UNITED STATES PATENT AND TRADEMARK OFFICE

APPLICATION NO.	FILING DATE	FIRST NAMED INVENTOR	ATTORNEY DOCKET NO.	CONFIRMATION NO.
10/814,132	04/01/2004	Hiroataka Kiyota	Q80851	8102

Office Action Summary	Application No.	Applicant(s)	
	10/814,132	KIYOTA, HIROTAKA	
	Examiner	Art Unit	
	Javaid Nasri	2839

DETAILED ACTION

FIG. 3A

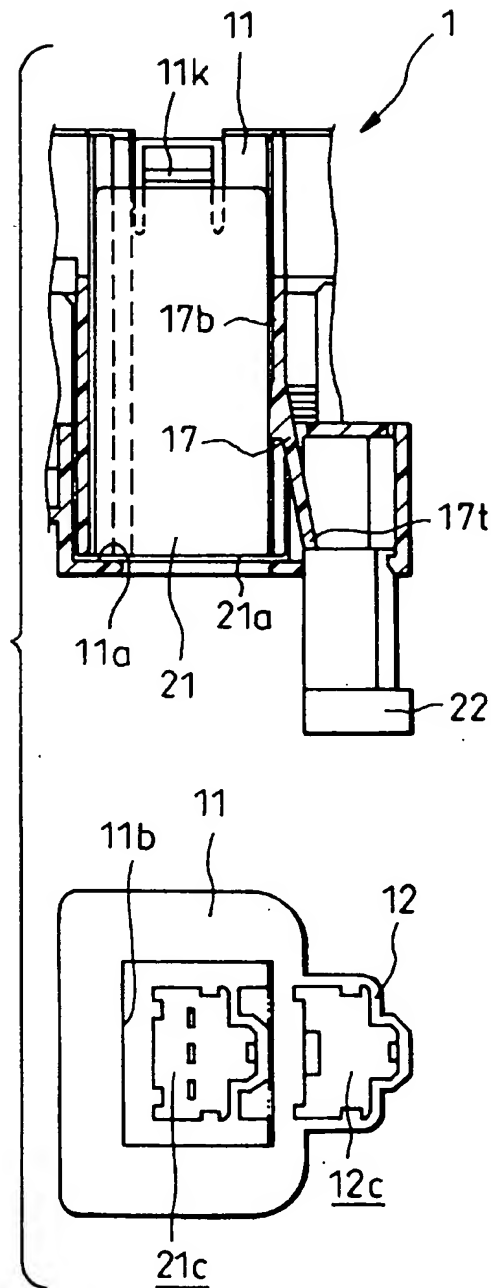
Higashida et al discloses, **for claim 1**, a box body; a provisionally-attaching portion (12) for provisionally attaching a first connector (22) connected to a wire harness to the box body provided to the box body (see figure 3A); and a circuit unit (21) including a second connector (21c) adapted to be mounted on the box body, wherein when the circuit unit (21) is mounted to the box body, the first connector (22) is detached from the provisionally-attaching portion (12) and is connected to the second connector (21c) (see figure 3B, see col. 7, lines 43-51), **for claim 2**, the provisionally-attaching portion is formed on a wall portion of the box body forming a receiving space for receiving the circuit unit, and when the circuit unit is received in the receiving space, the provisionally-attaching portion is disposed between the wall portion and the circuit unit (see figure 1), **for claim 3**, the provisionally-attaching portion including a guide rib which is formed on the wall portion and extends in a direction in which the first connector (22) is inserted (see figure 3A), and the first connector (22) includes a guide groove for sliding engagement with the guide rib (see marked figure 3B, attached), **for claim 4**, the provisionally-attaching portion includes a pair of side ribs provided at opposite sides of the guide rib, respectively, and the first connector includes a pair of side guides for engagement respectively with the pair of side ribs (see marked figure 3B, attached).
